Access Compliance Report

Public Rights-of-Way

Intersection ID: 11727	Main Street: W_8TH_ST	Cross Street: N_POPLAR_ST	Location:	E
ADA ID: C7C8E095B481	Ramp Type: PerpDiag	Initial Pass/Fail: Fail	Overall Compliance: No	Severity Score: 25

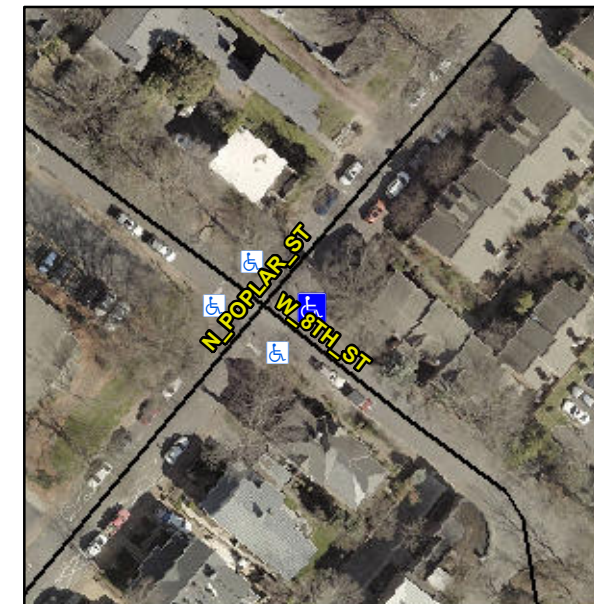
Not Found, R304.2.2

Compliance	Description	Data	Compliance	Description	Data
N/A	Ramp Length (in)	41.0	No	Ramp Slope (%)	12.0
Yes	Ramp Width (in)	48.0	Yes	Ramp XSlope (%)	1.9
N/A	Flare Type LT	N/A	N/A	Flare Type RT	N/A
N/A	Flare Slope LT (%)	N/A	N/A	Flare Slope RT (%)	N/A
N/A	Flare Traversable LT?	N/A	N/A	Flare Traversable RT?	N/A
N/A	Landing Length (in)	N/A	N/A	DWS Provided?	N/A
N/A	Landing Width (in)	N/A	N/A	DWS Contrast?	N/A
N/A	Landing Slope (%)	N/A	N/A	DWS Length (in)	N/A
N/A	Landing X Slope (%)	N/A	N/A	DWS Full Width?	N/A
N/A	Landing Curb? (Y/N)	N/A	N/A	DWS Offset (in)	N/A
N/A	Shared Landing?	N/A			
N/A	Gutter Ponding?	N/A	N/A	Gutter Slope (%)	N/A
N/A	Gutter Lip Ht (in)	N/A	N/A	Gutter X Slope (%)	N/A
N/A	Painted X Walk1?	No	N/A	Painted X Walk2?	No
	X Walk 1 Direction	To NW		X Walk 2 Direction	To SW
N/A	X Walk 1 Width (in)	N/A	N/A	X Walk 2 Width (in)	N/A
	X Walk 1 Slope (%)	4.8		X Walk 2 Slope (%)	2.1
	X Walk 1 X Slope (%)	0.6		X Walk 2 X Slope (%)	6.0

Remove & Replace Curb Ramp With Two New Directional Ramps or Equivalent.
